PROJECT : ZR1/ZR2

Quanta Computer Inc.

POWER BOARD

## CAREMA USB CONN

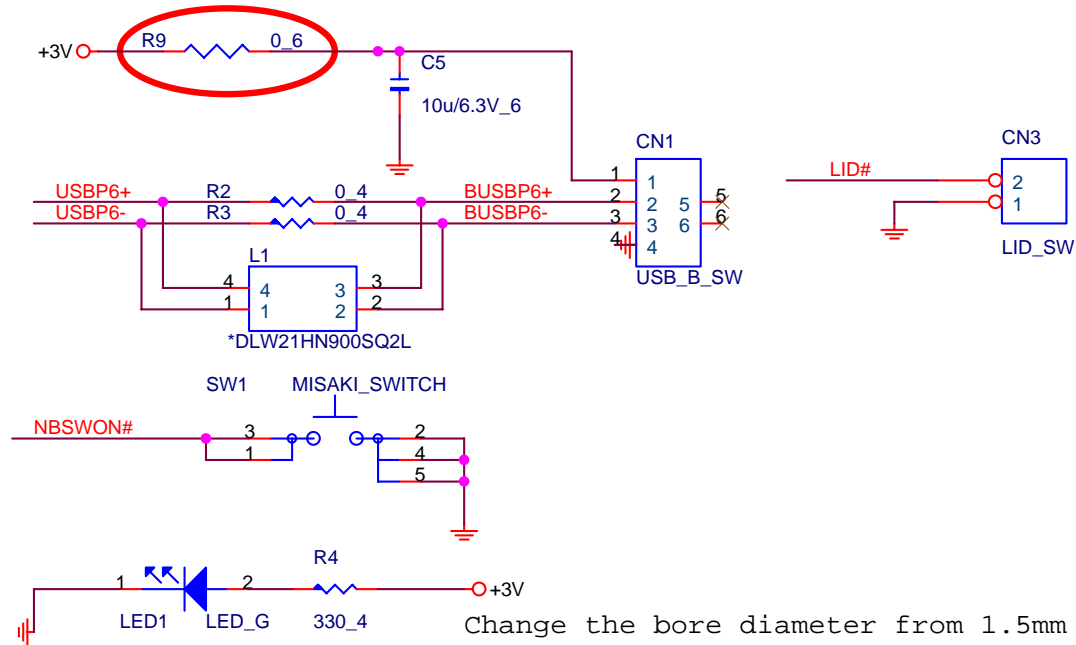
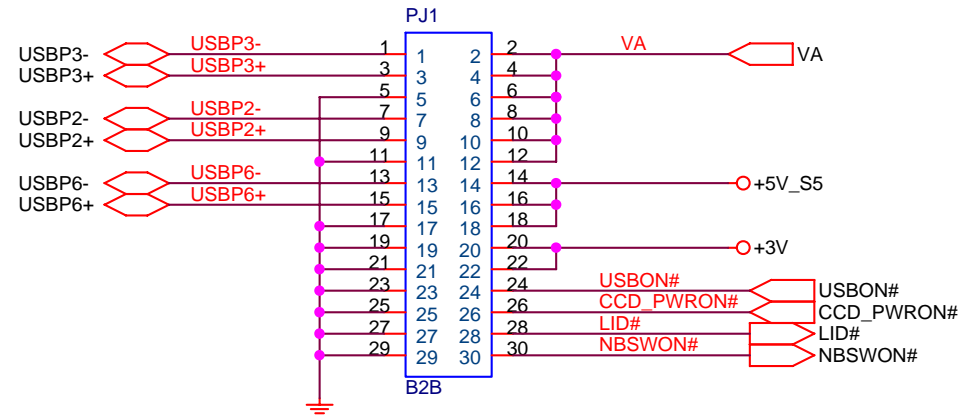
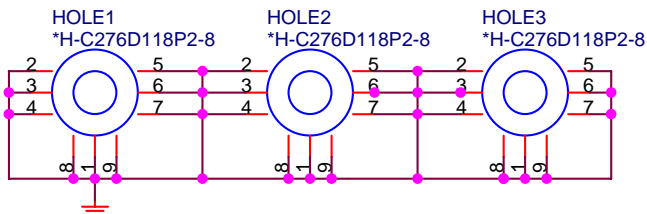
Follow ZB2 project to delete the Q1 and add R9

Change the bore diameter from 1.5mm to 3.0mm

## USB CONN

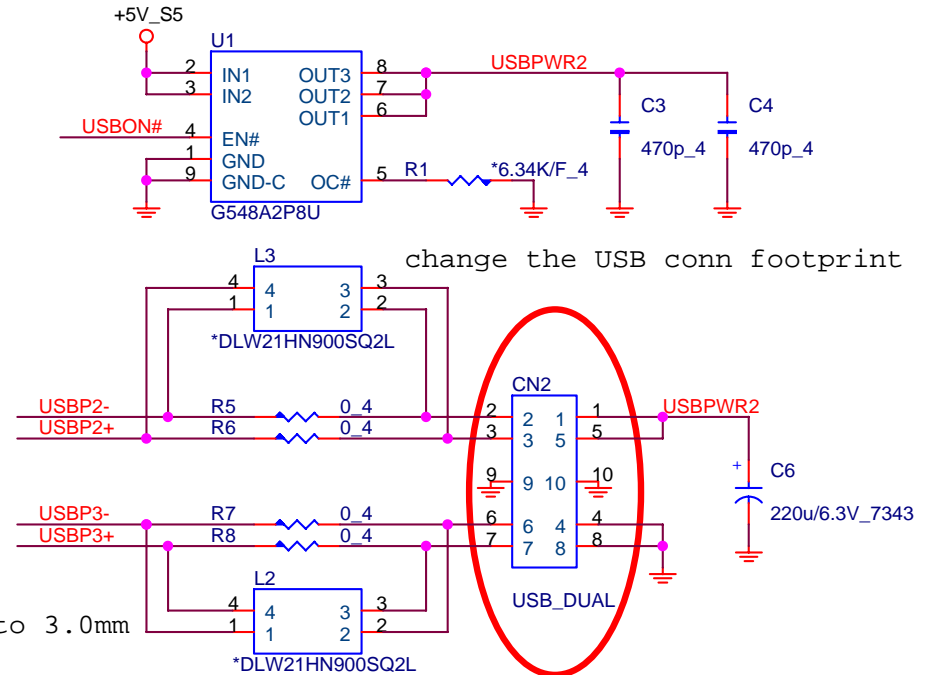
change the USB conn footprint
